Falcon Landing

FALCON LANDING
7344 McLAUGHLIN ROAD
FALCON, CO. 80831

PLOT PLAN LOT 3 BECKETT AT WOODMEN HILLS

PROJECT: BECKETT AT WOODMEN HILLS LOT 3
SHEET TITLE: SITE PLAN
FROM: n/a TO: n/a
JOB NO. 06-0056 SHEET 1 OF 1

SE Springs Engineering
 25 N. TEJON, SUITE 200
 COLORADO SPRINGS, CO 80903
 P: (719) 227-7388
 F: (719) 227-7392
 PROJECT: BECKETT AT WOODMEN HILLS LOT 3
 SHEET TITLE: GRADING PLAN
 FROM: n/a TO: n/a
 JOB NO.: 06-0056 SHEET 2 OF 7

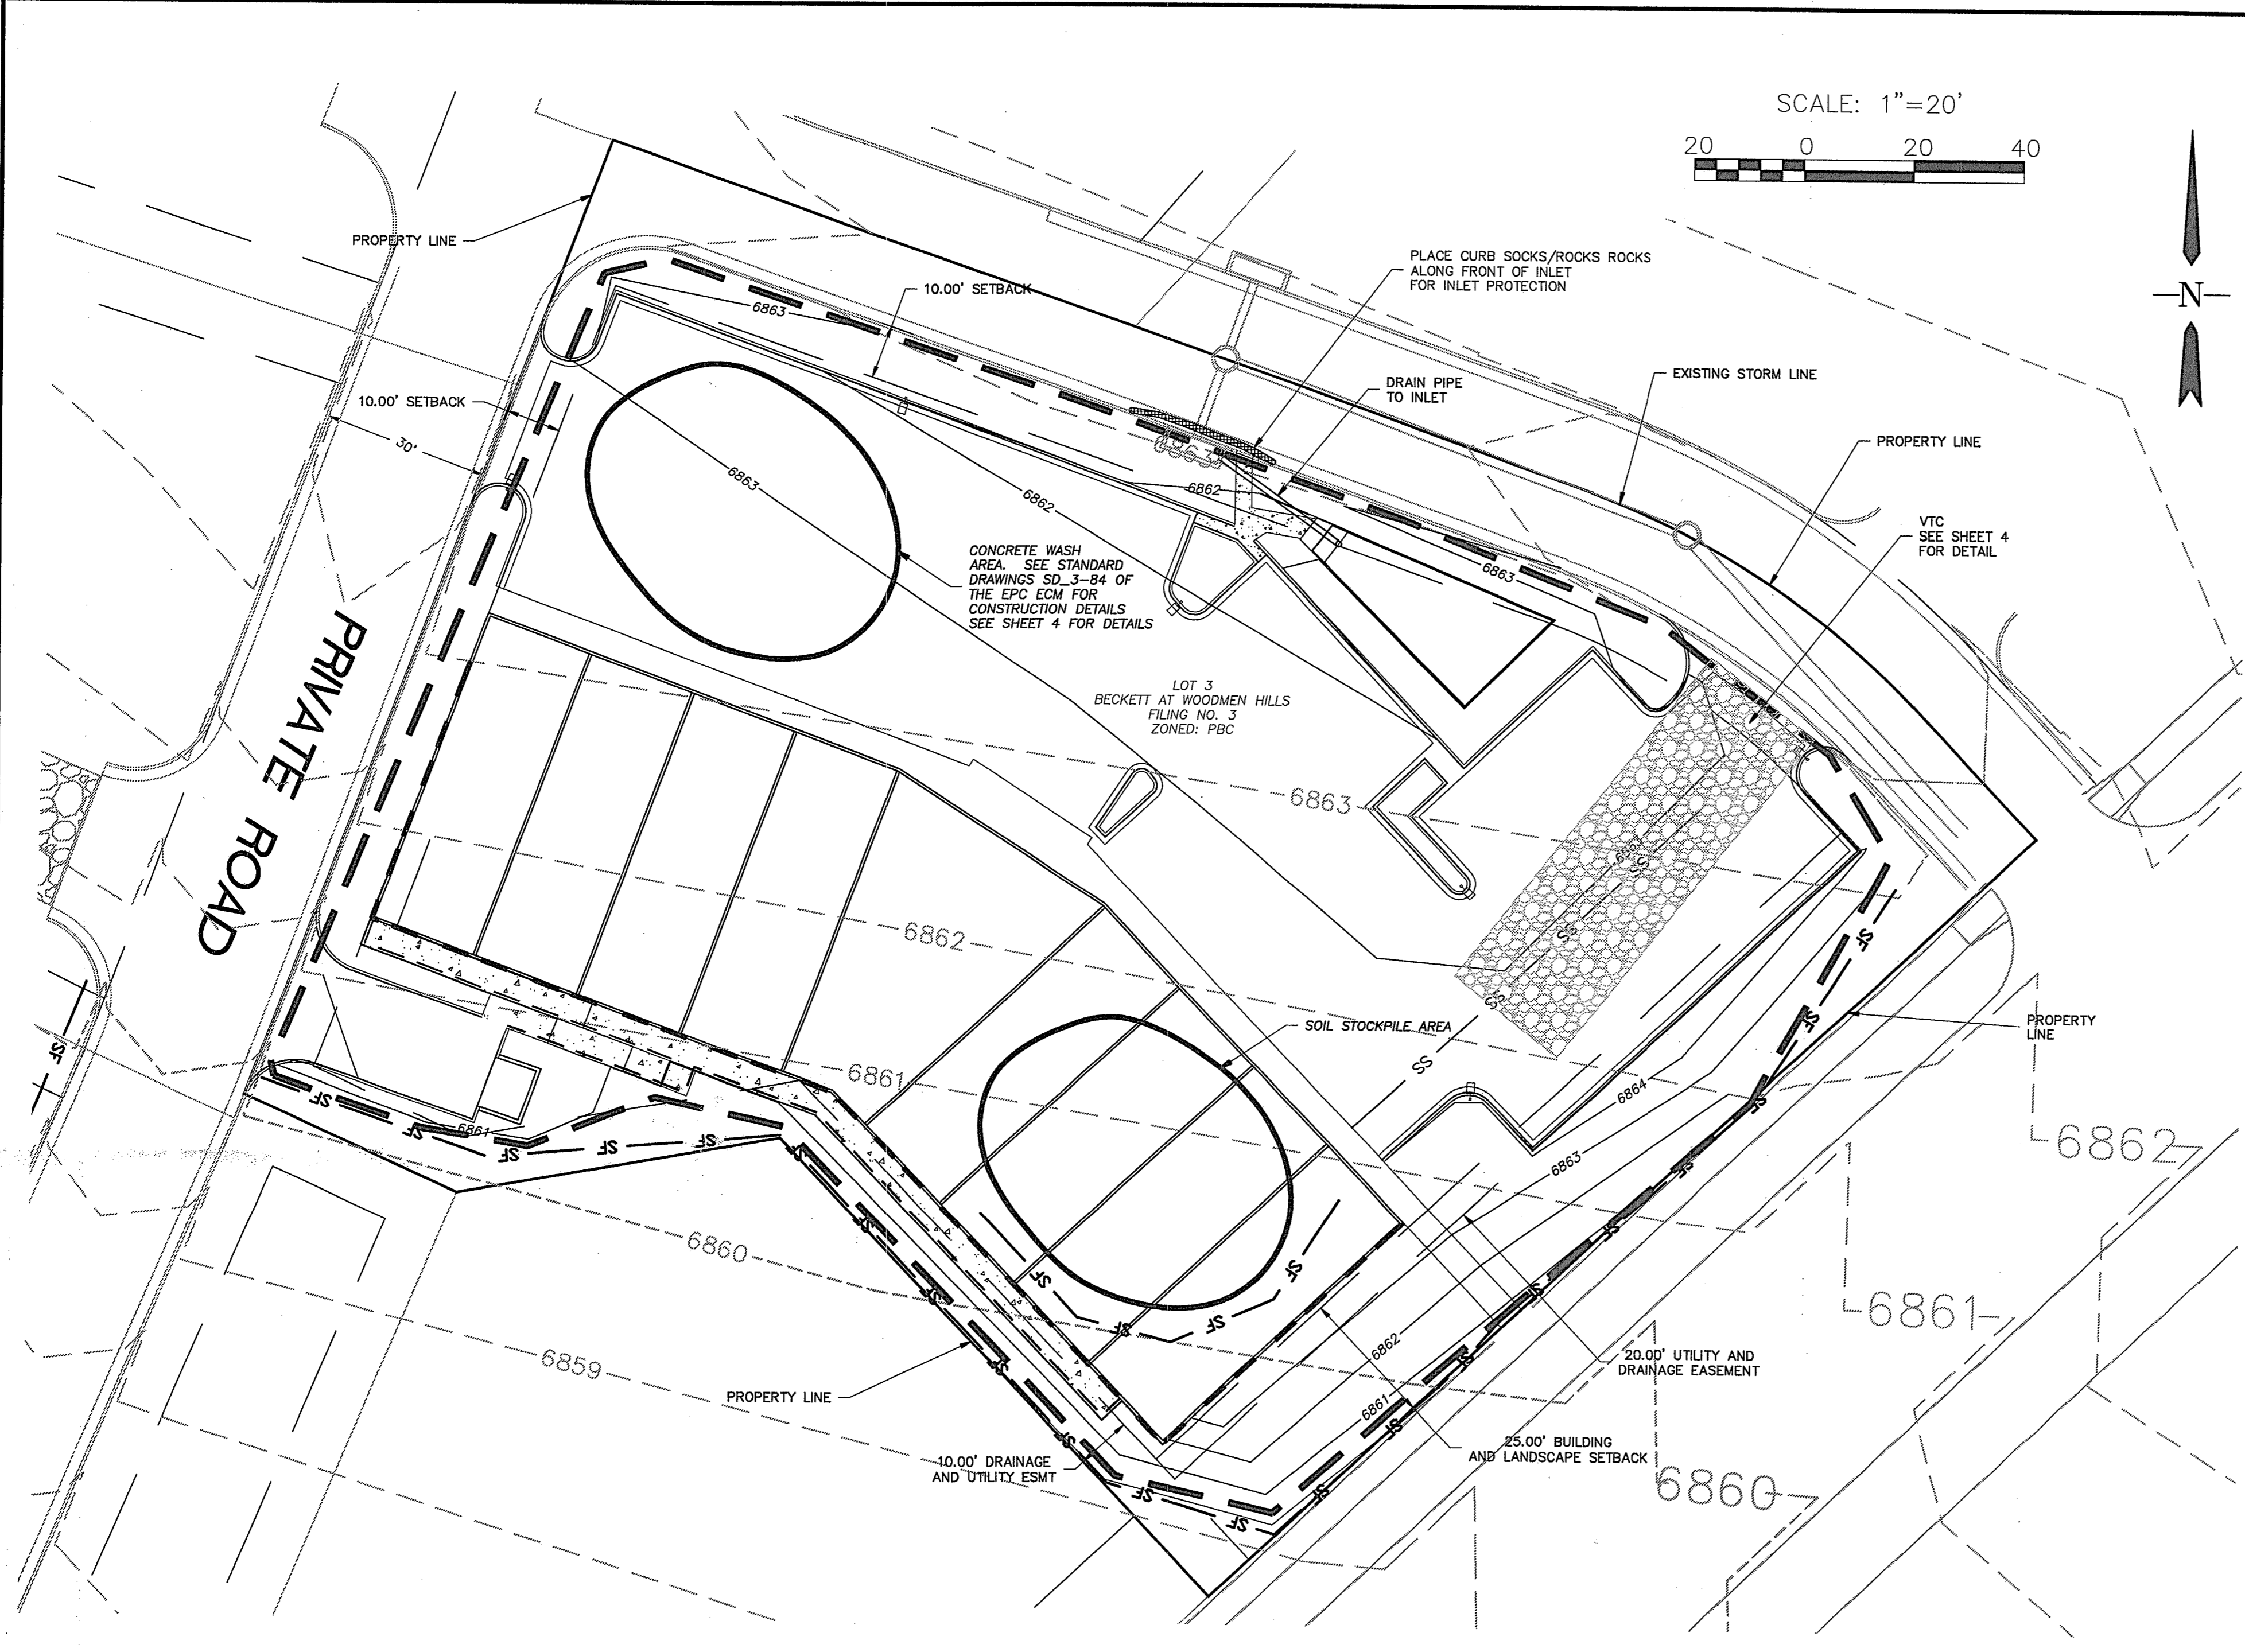
- ONCE THE ESQCP HAS BEEN ISSUED, THE CONTRACTOR MAY INSTALL THE INITIAL STAGE EROSION AND SEDIMENT CONTROL BMPs AS INDICATED ON THE GEC. A PRECONSTRUCTION MEETING BETWEEN THE CONTRACTOR, ENGINEER, AND EL PASO COUNTY WILL BE HELD PRIOR TO ANY CONSTRUCTION. IT IS THE RESPONSIBILITY OF THE APPLICANT TO COORDINATE THE MEETING TIME AND PLACE WITH COUNTY DSD INSPECTIONS STAFF. **Change DSD to FCD throughout notes**

Add this note for a total of 27 notes.

1. Construction may not commence until a Construction Permit is obtained from Planning and Community Development (PCD) and a preconstruction conference is held with PCD Inspections.
